TCEP Project No.: 439-080-15

ADDENDUM NO. 2

**Lied Science & Mathematics Building
Rooms B100 & 209
Renovation**

Item 2-2: M2.02 Basement Underfloor & Basement Plumbing Plans

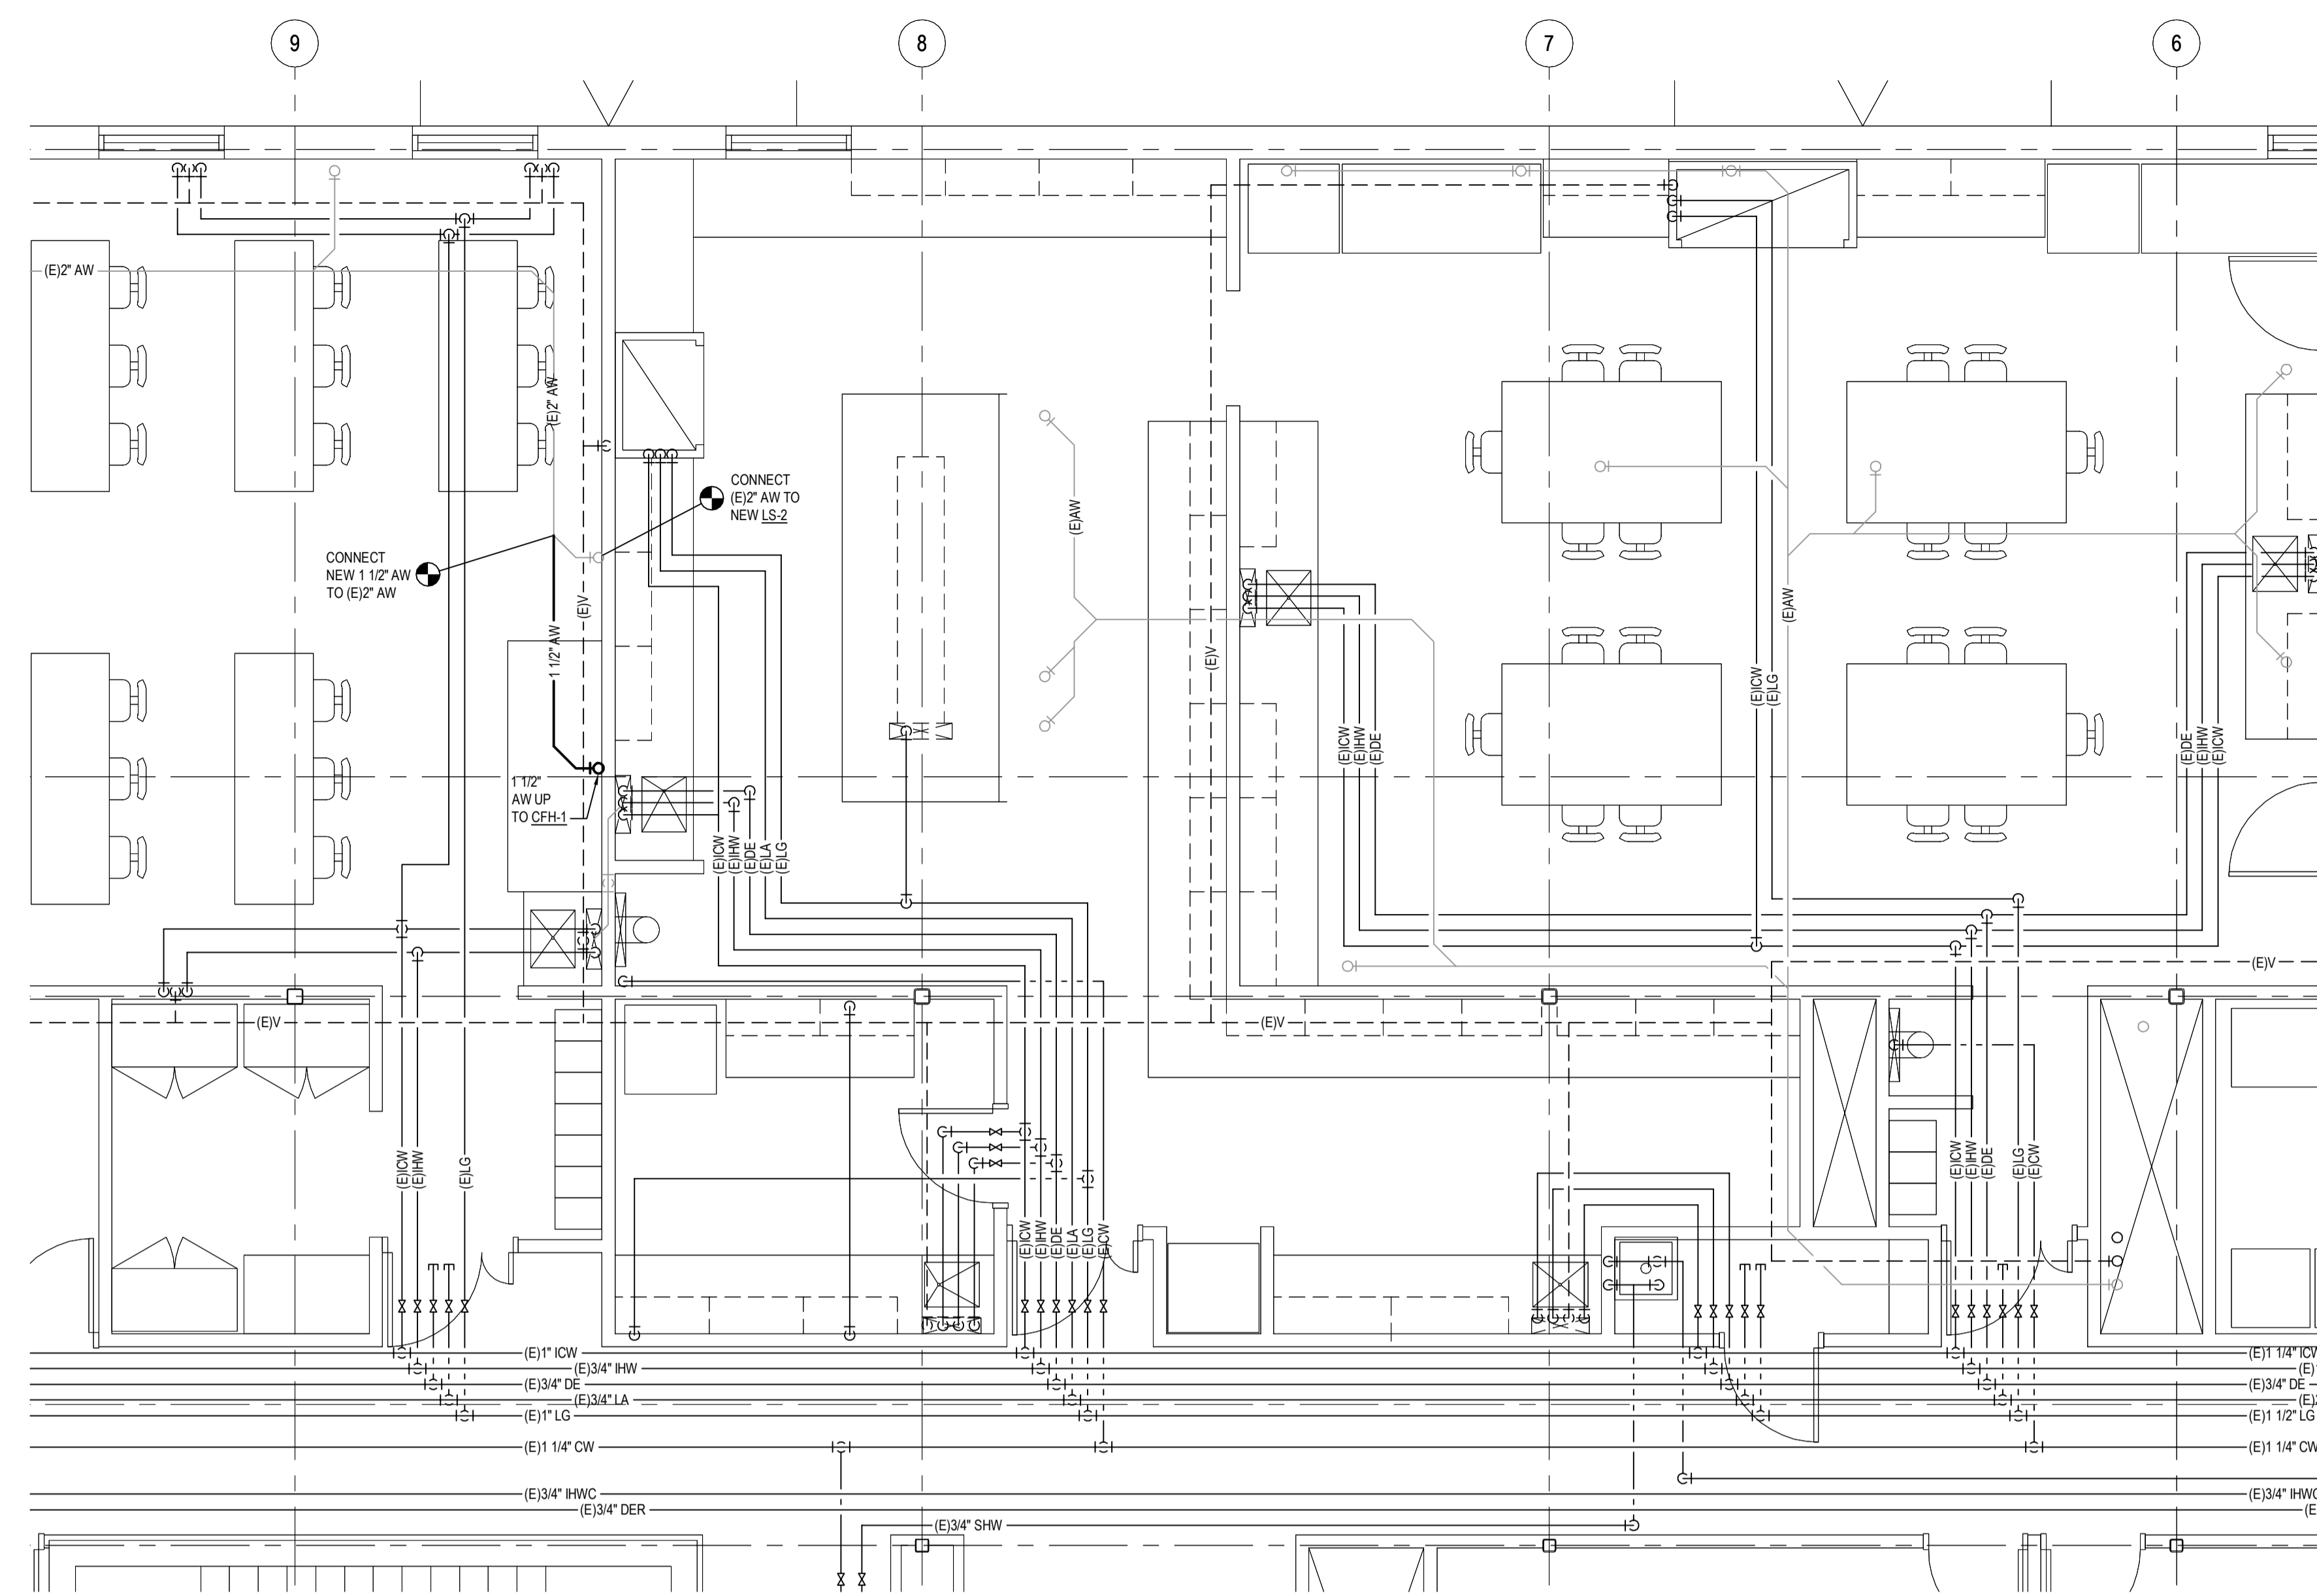
Sheet M2.02 has been reissued in its entirety to show changes to vent piping in B100.1 Chemical Storage. 1-1/2" V piping from LS-1 and CFH-1 has been changed from acid vent piping to vent piping and will tie into (E)1-1/2" V piping.

Item 2-3: M2.03 First Floor & Second Floor Plumbing Plans

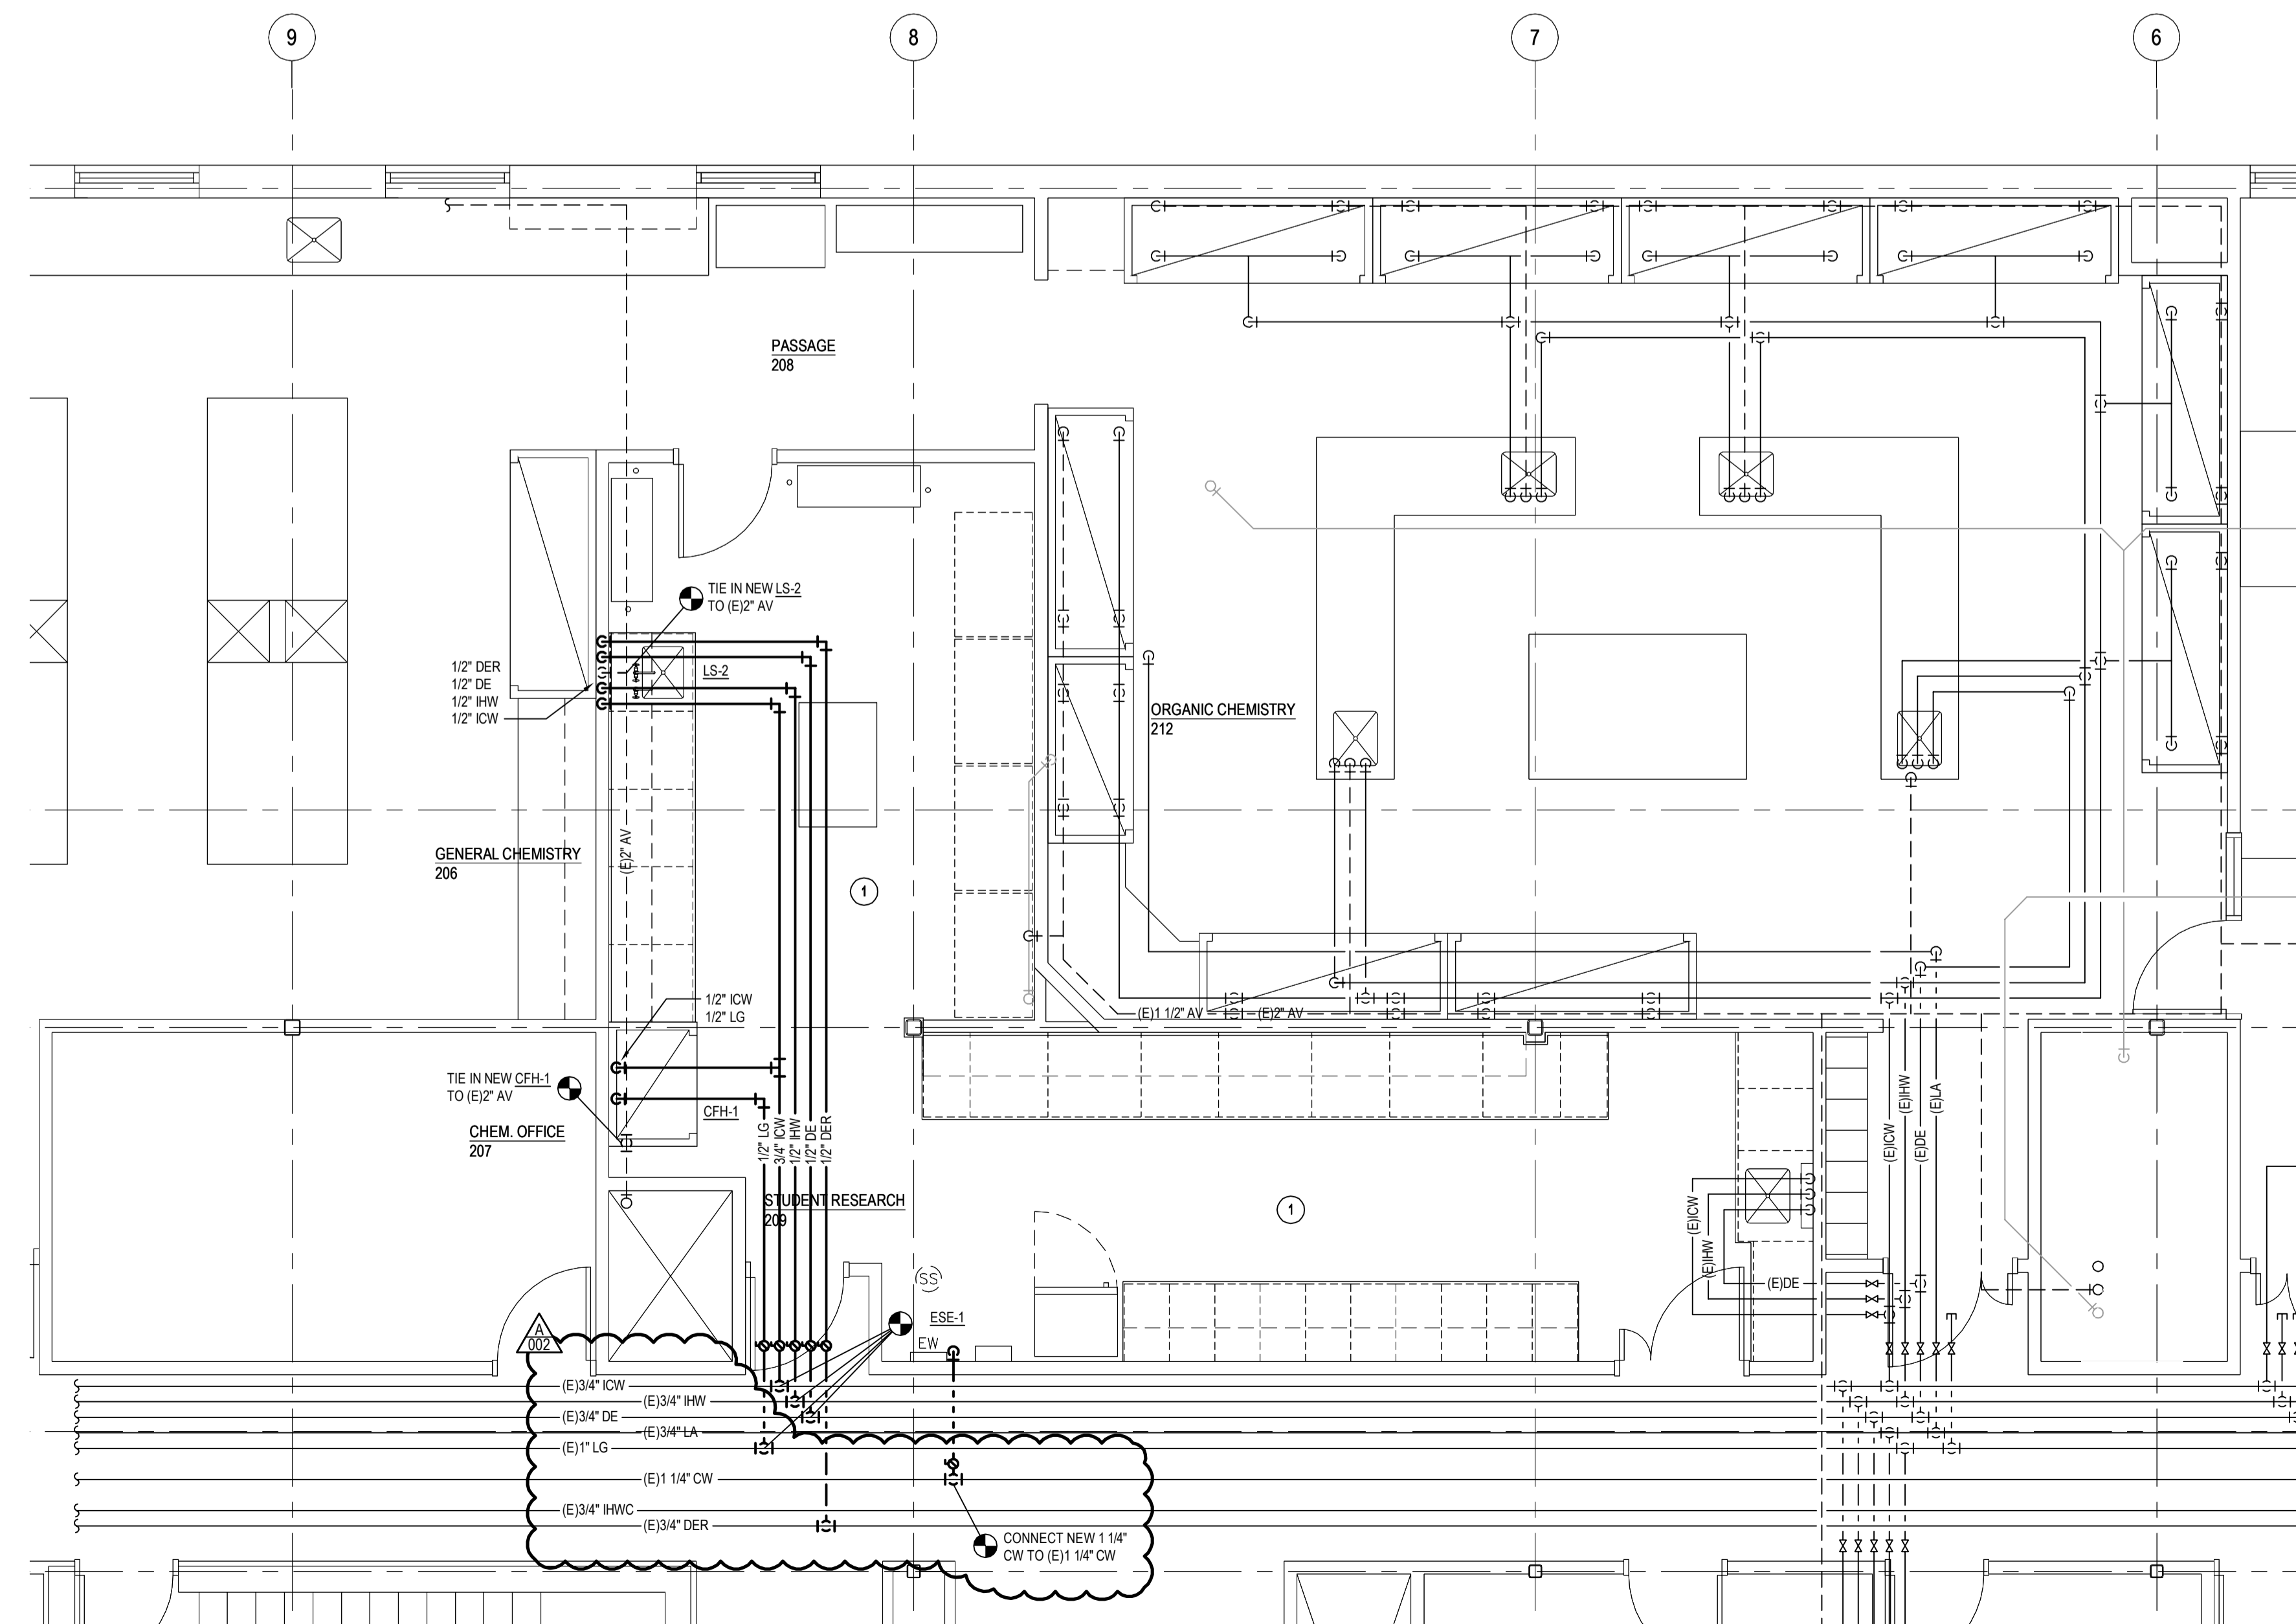
Sheet M2.03 has been issued in its entirety to show sizes on existing ICW, IHW, DE, LA, LG, CW, IHWC, and DER piping mains.
